**Gentech  
(Site Plan)**

GENTECH SITE PLAN - RT. 9W (CUOMO) **99-20**  
NEW BUILDING

**SUBJECT: GENTECH SITE PLAN (P.B. # 99-20)**

**TOWN OF NEW WINDSOR  
PLANNING BOARD  
REVIEW COMMENTS**

Specifications for Lighting.

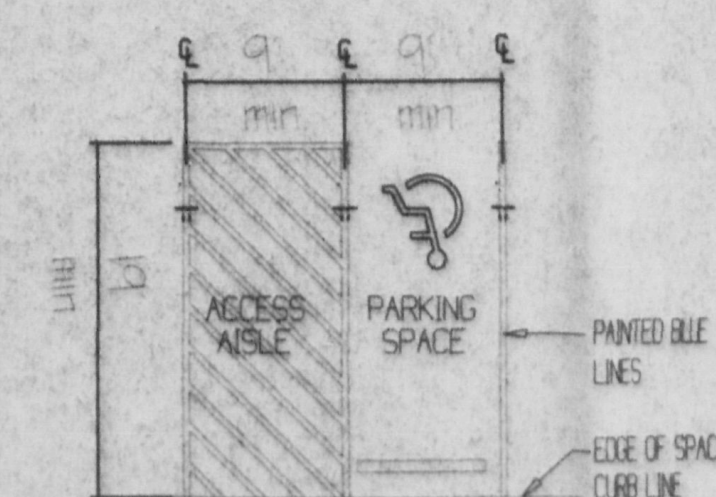
know that this is the type of lighting that you want or I don't know the applicant would be pleased with the type fixtures shown, shown on drawing 2 up in the upper right-hand corner like a flood light, 20 foot high pole with a directional flood light.

- e. On Sheet SP-2, a typical lighting pole is depicted. It is my opinion that this spotlight type fixture is inappropriate for this area and is not the type lighting fixture normally desired by the Planning Board, adjoining residences and adjoining highways. The Board should discuss this with the Applicant.

- i. The site lighting detail would appear to be incomplete, since the mounting height and manufacturer/model number have not been identified on the plan. A copy of the isolux curve for the specific light should be provided.

## HANDICAPPED SPACE DETAIL

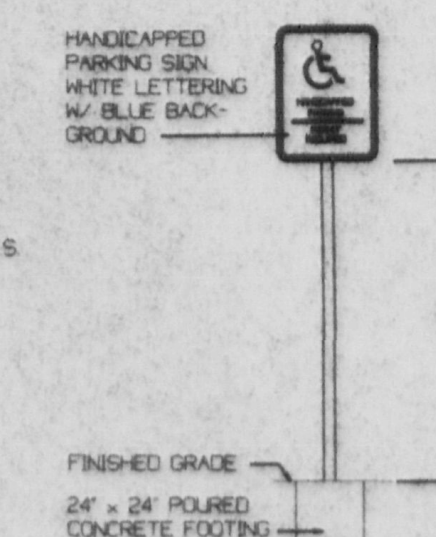
- h. The handicapped parking space detail on Sheet 2 notes white striping. All striping must be blue, as per State requirements. In addition, a handicapped parking sign must be detailed.

LANDSCAPE PLAN

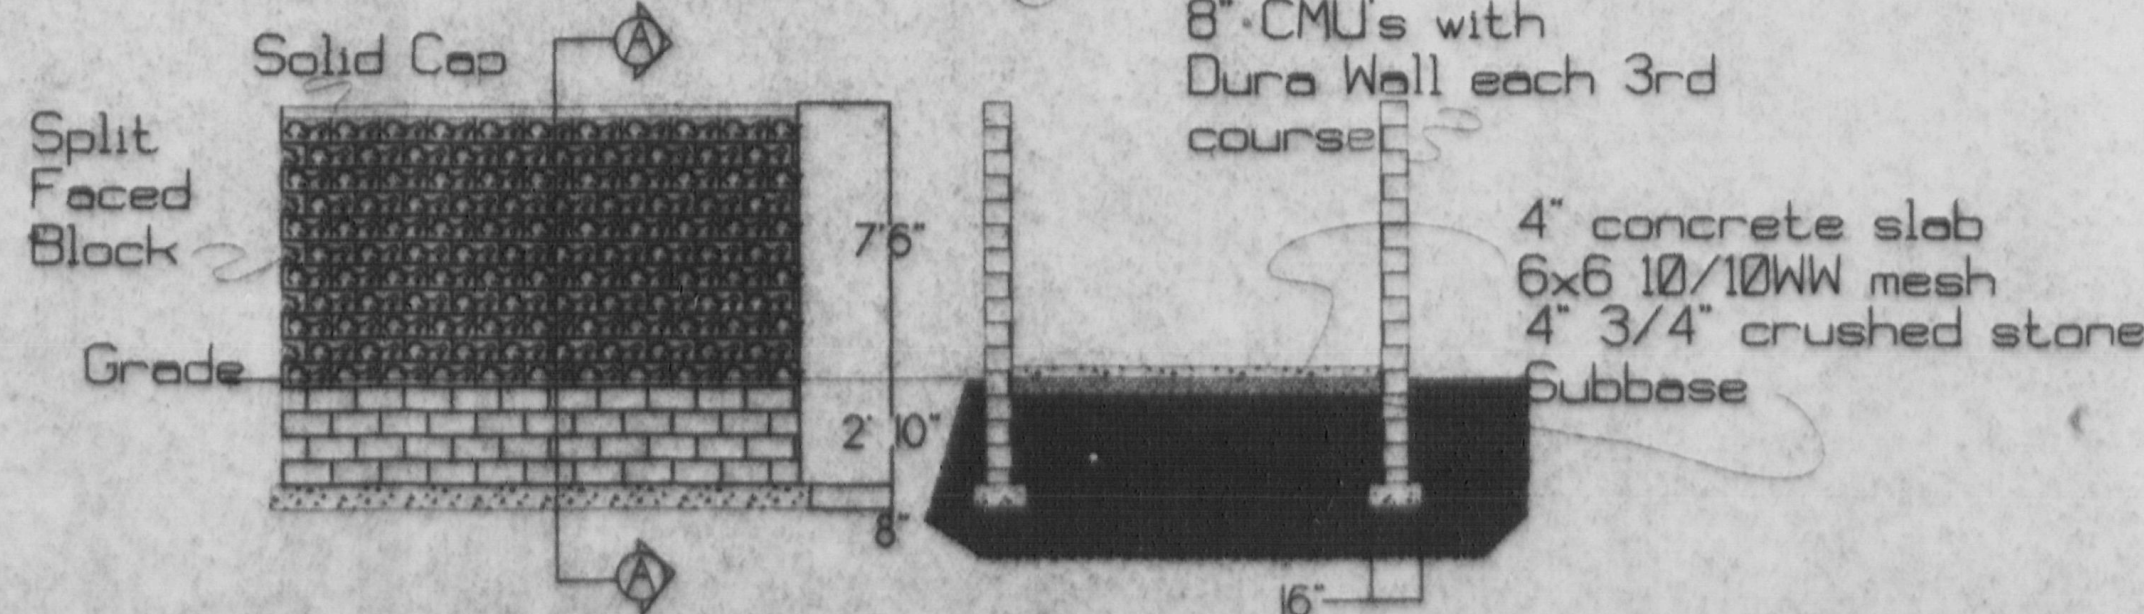
- f. Drawing SP-3 is identified as a landscaping plan. This drawing would appear to depict a few plantings on the site, although these are not identified. A planting schedule and details may be appropriate.
4. I am not aware of any response from the New York State Department of Transportation with regard to this proposed access. It is recommended that a response be on file before the Board takes any action.
5. The Planning Board may wish to assume the position of **Lead Agency** under the SEQRA process.
6. The Planning Board should determine, for the record, if a **Public Hearing** will be necessary for his **Site Plan**, per its discretionary judgement under Paragraph 48-19.C of the Town Zoning Local Law.
7. At such time that the Planning Board has made further review of this application, **further engineering reviews** and comments will be made, as deemed necessary by the Board.

PARKING & DRIVE SECTION

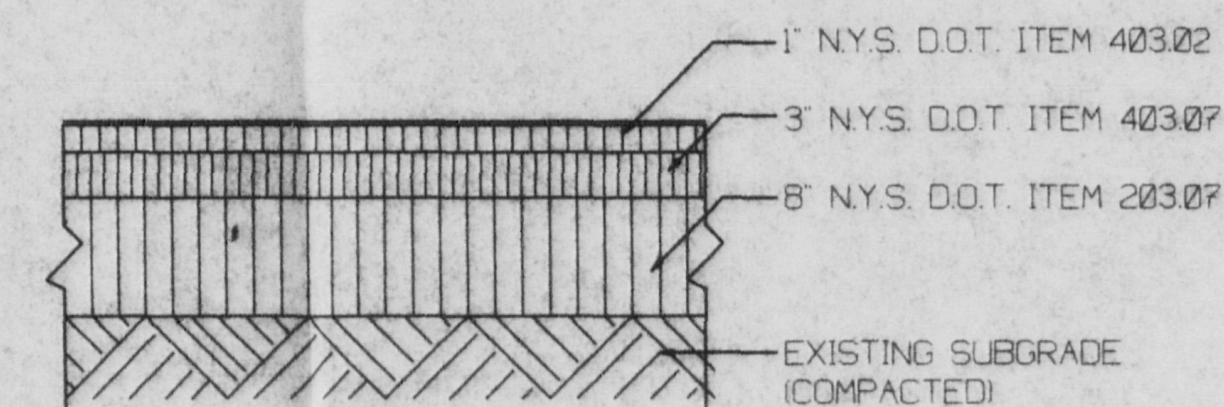
- j. The parking and drive section calls for a 4" oil and chip top course, which I believe is nearly impossible to accomplish with oil and chip. A proper paving course should be identified in the detail. As well, the term "crushed stone" should be replaced with subbase material on the parking and drive section.
